**RE: CONTRACT NO.: 13/WSD/17
DESIGN, BUILD AND OPERATE FIRST STAGE OF TSEUNG KWAN O
DESALINATION PLANT
Submission of Detailed Design Plan for Chlorine and Carbon Dioxide Storage
of Desalination Plant**

Detailed Design Plan for Chlorine and Carbon Dioxide Storage of Desalination Plant

**First Stage of Desalination Plant at Tseung Kwan O – Investigation, Design and Construction
Detailed Design Plan for Chlorine and Carbon Dioxide Storage of Desalination Plant
IEC Verification Letter**

Submission No.	TKOD1-RPT-A000-JGN0003-04		
Subject	Submission of Detailed Design Plan for Chlorine and Carbon Dioxide Storage of Desalination Plant	Date	9/07/2021
Version	04	Page	1 of 2

Figure 2: Building Separation Distances

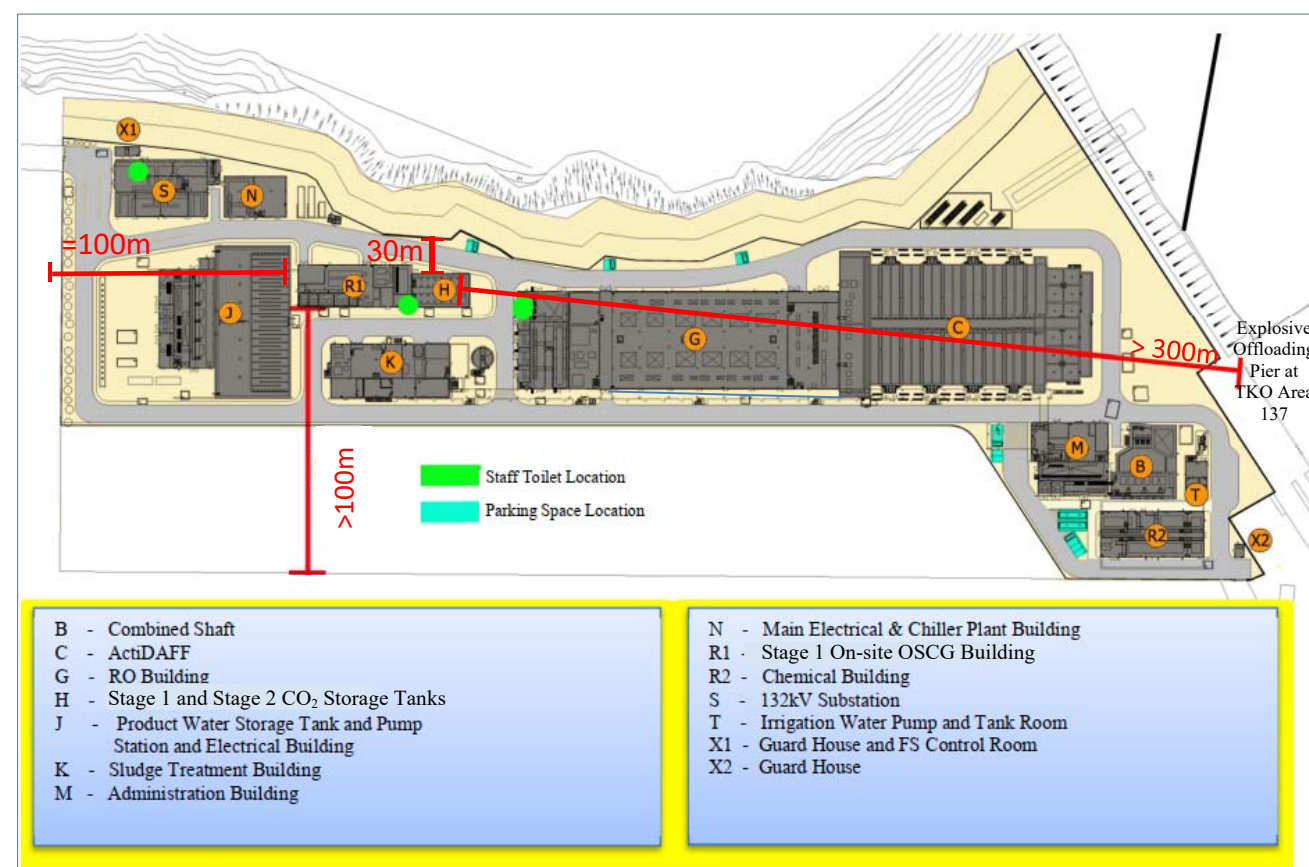
6. Figure 1 shows that the OSCG plant is “<100m” from the boundary. Please check. Also, please check the distance between the OSCG plant and the northern boundary of the desalination plant.	The OSCG plant is “>100m” from both the western and northern site boundary as per updated current design. Please refer to Appendix B-1 for detailed location.

The separation distance of more than 100m between the CO₂ storage tank area and all the site boundaries (not including hill side) will be maintained under the current design in accordance with the requirements of the Environmental Permit (EP). The CO₂ storage tank area is about 30 m away from the toe of natural slope (**Figure 2** refers). The centre / exhaust points / louvers of the Stage 1 OSCG building and its nearest site boundaries is currently designed to be no less than 100 m. Detailed design of the Stage 2 OSCG system will be carried out at a later Project stage. The reference design of the Stage 2 OSCG system presented in the Environmental Review Report (ERR) (see **Section 7** below) is assumed to remain valid. Any future changes of the Stage 2 OSCG design will be submitted to the Environmental Protection Department (EPD) for approval prior to commencement of the Stage 2 construction works.

Appendix B - 2: Process & Instrumentation Diagrams (P&IDs) of Remineralisation CO₂ Storage Tanks and Related Systems

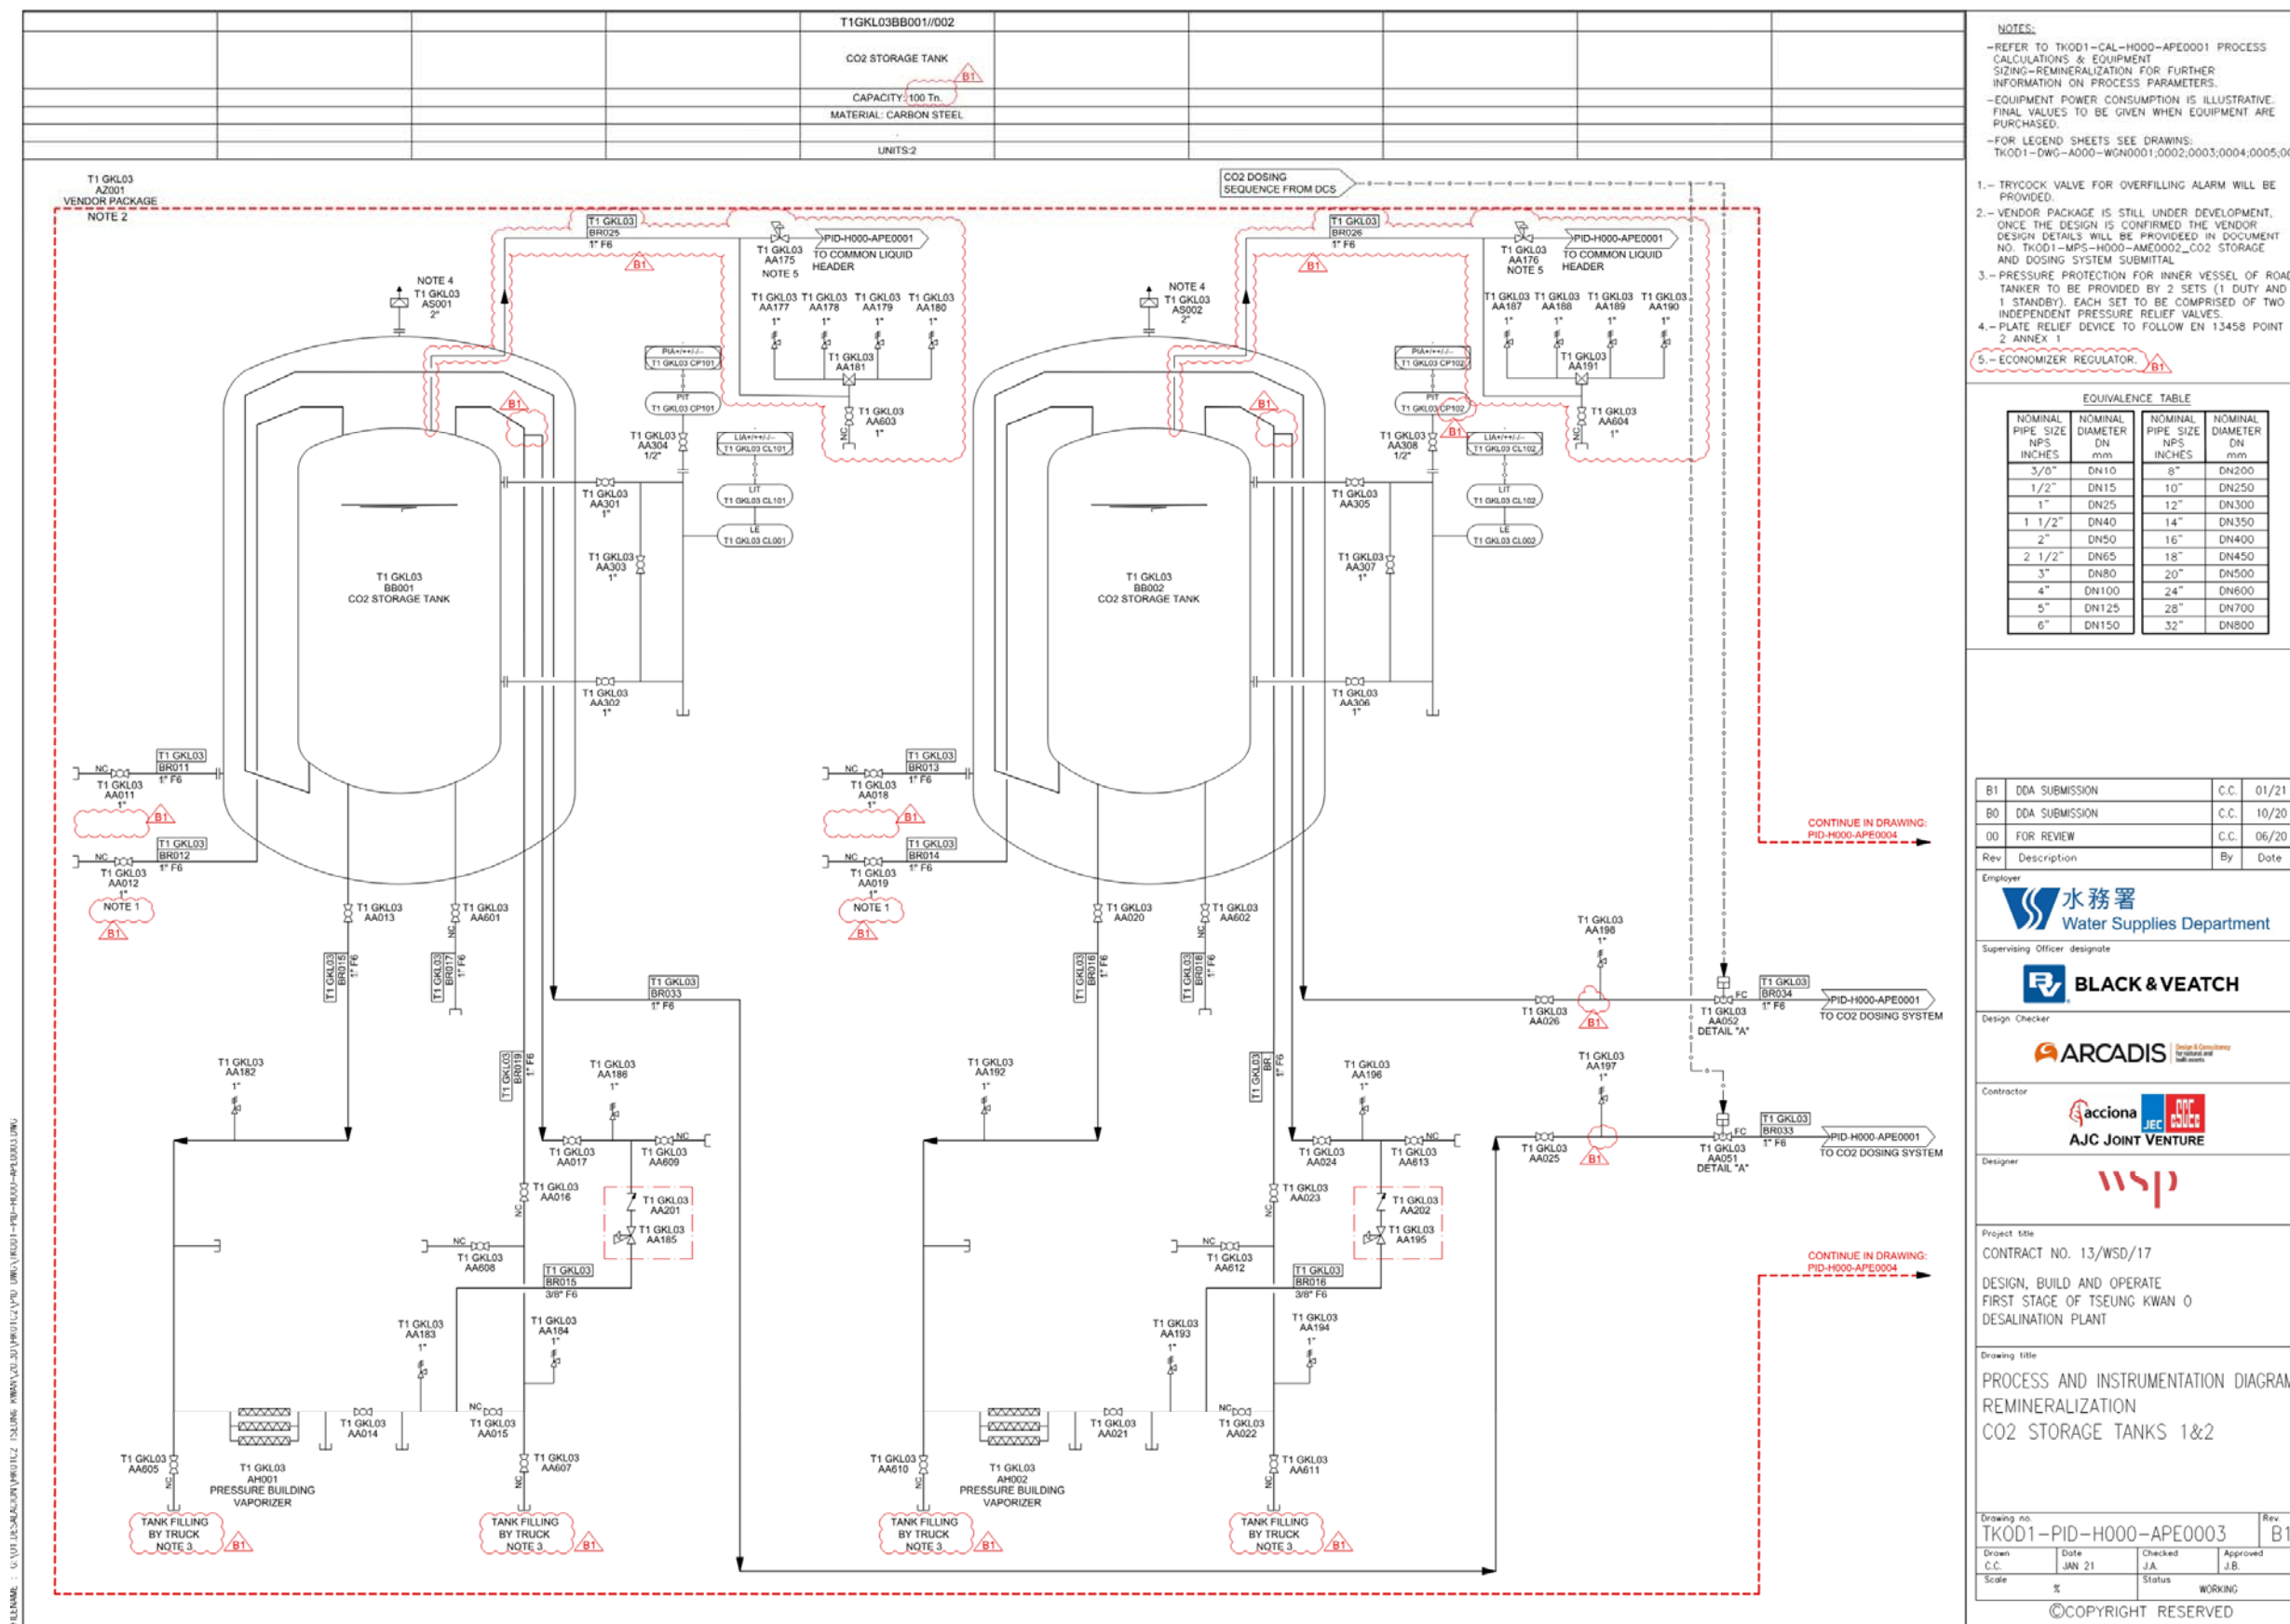
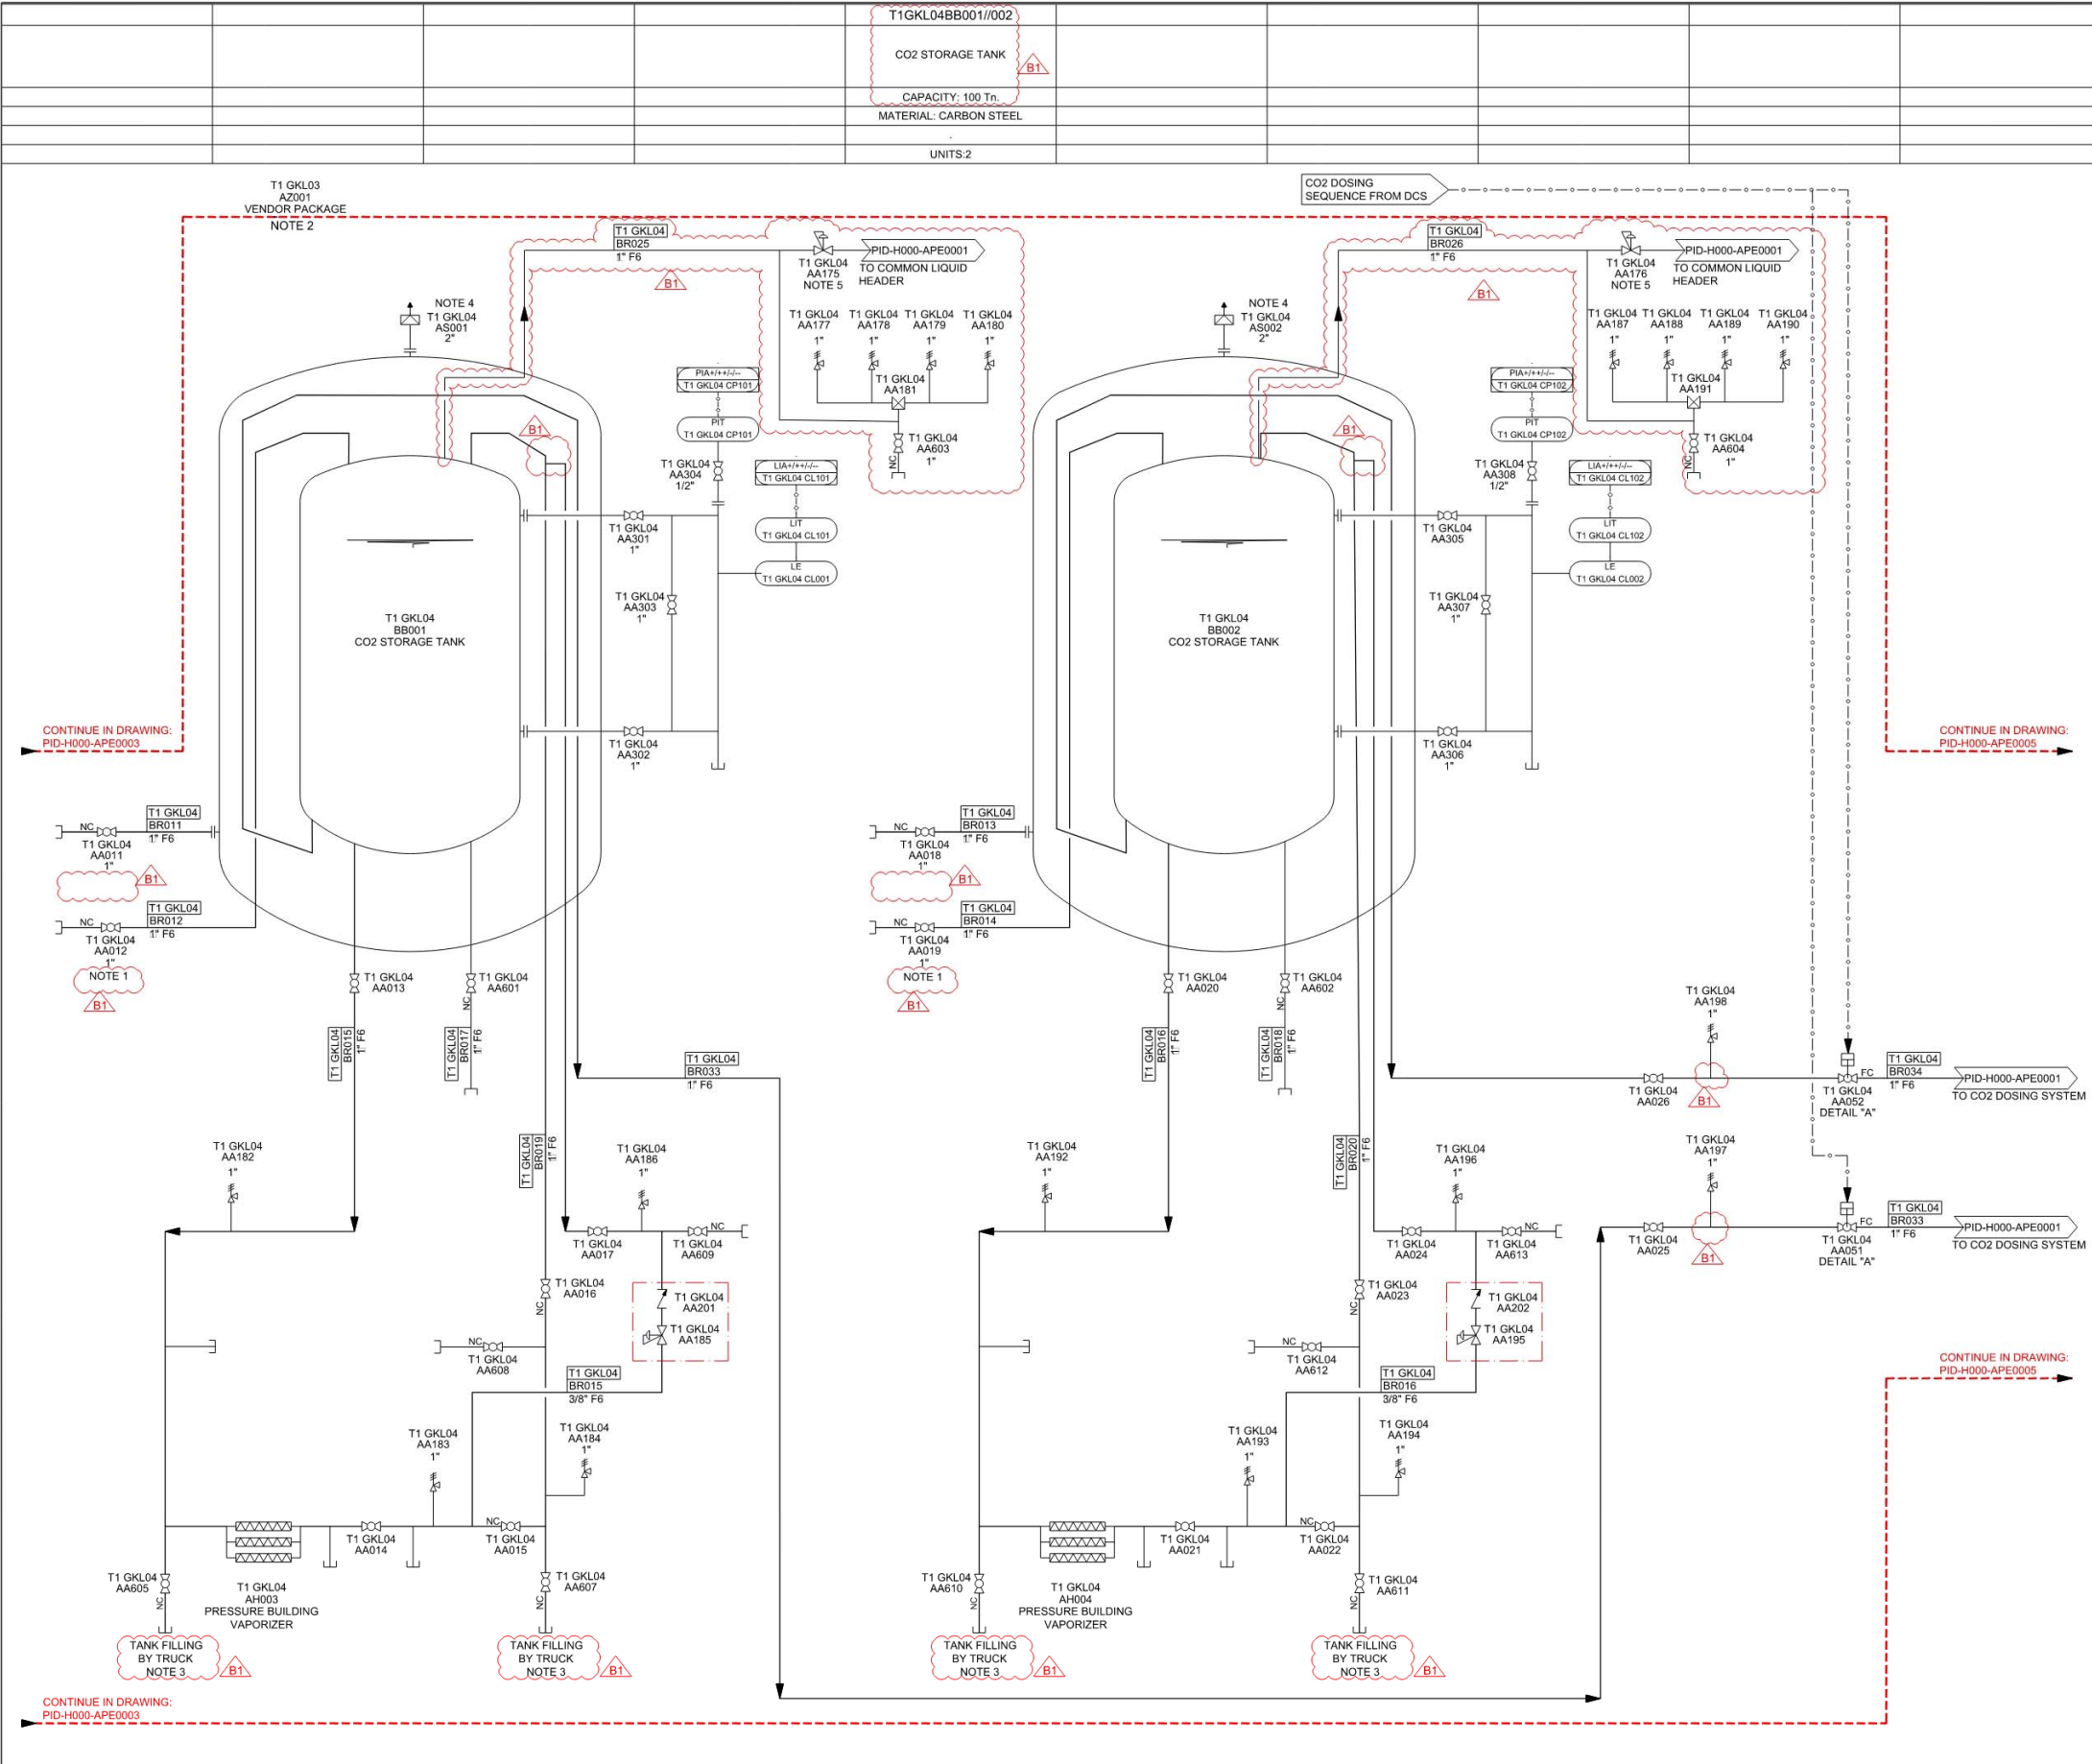
2. Appendix B Please explain how the design of the pressure relief valves system can avoid common mode failure.	Explanation has been added in Appendix B-5 of the revised plan. The P&IDs in Appendix B-2 have also been revised.
